cargo hold painting requirements & comments

Slop Tank

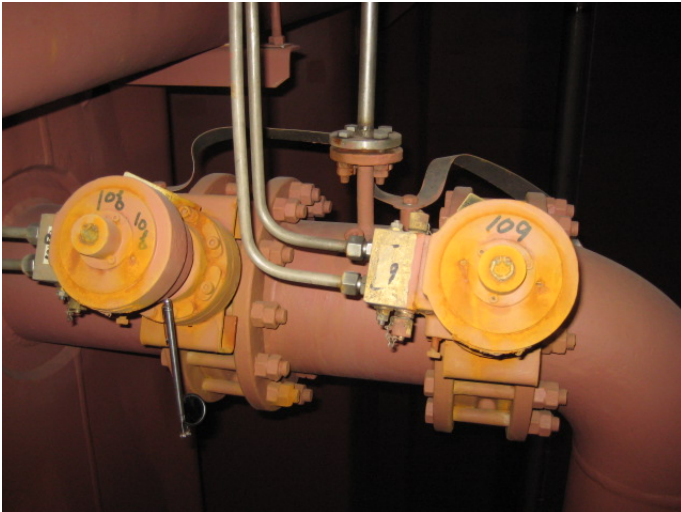
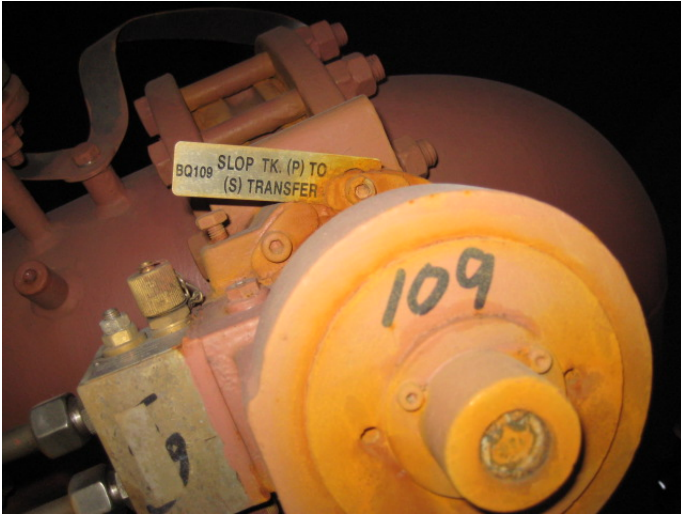
1: 对于厂家来货的阀门, 要求不锈钢液压管和顶部转轴及批示针盘进行妥善包覆盖保护, 不进行冲砂和油漆. 但其它表面进行扫砂和油漆

For the valve, require to no blasting and painting for the stainless hydraulic pipe and axes with the indicating disc, please protect it. Other surface to be sweep blasting and painting.

2: 如果错误的材料 U 型螺栓,必须进行更换至正确材料. 同时对不锈钢套节,电焊及打磨后在适当的时期进行钝化. 钝化处理要求由油漆部门按照相关工艺进行, 避免其他工种不小心的施工导致钝化液滴在油漆表面,损坏油漆质量.

The wrong material U kind bolts, must be changed to correct material. For the stainless sleeve, after welding, it should be passivated. The passivation to be carried out by painting department painter according concerned workmanship, in order to avoid any passivation liquid drop to damage coat by careless.

B1, 2008-04-22, Residul Tank

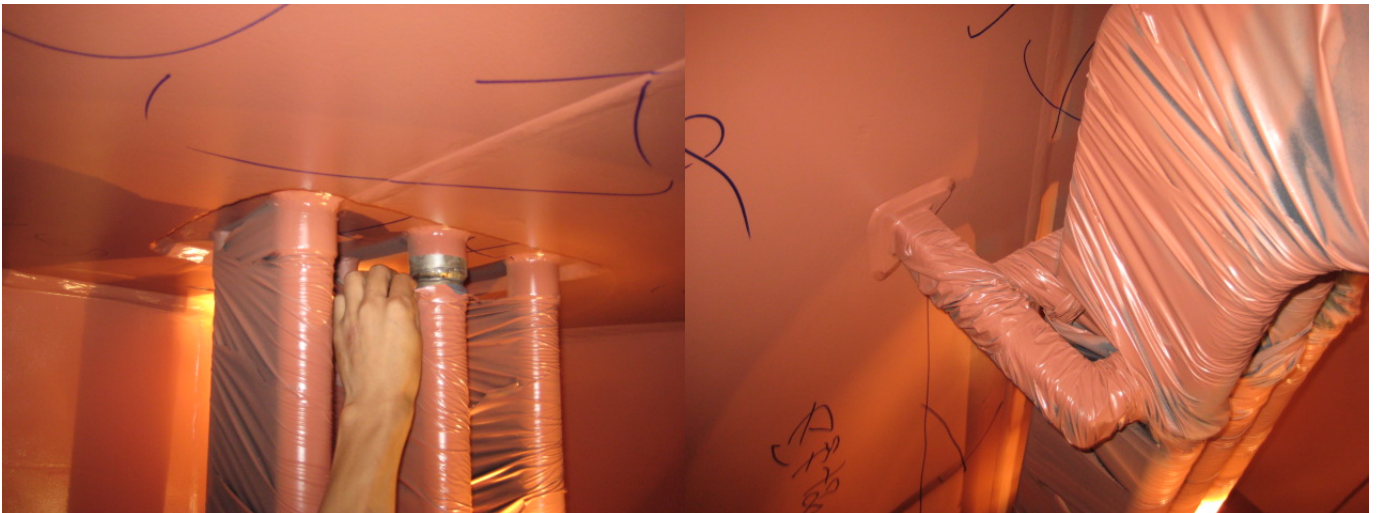
3: 错误材料的半圆形吊耳,必须更换至正确的材料

The wrong material of hinge half ring must be renew to correct material.

4: 包扎至露出套节的焊缝

The cover boundary to expose the welding seam of sleeve

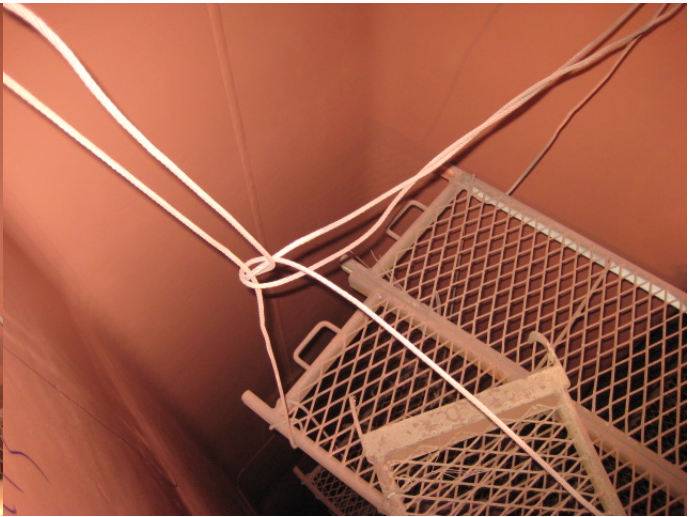
- 5: 不允许在加热管上留下胶带或是油漆
The tape or paint on the heating coil is unacceptable

- 6: 在槽型舱壁处的脚手架,有些太低,油漆工不够高,不利于反顶的打砂皮纸的 DFT 检查. 并且空间宽度太大,不安全
the stage in the corrugated bulkhead to be set a lit bit up, because it is down, the painter is not enough tall to reach the ceiling to do such as hand paper grind and DFT check. And the space too big, dangerous.
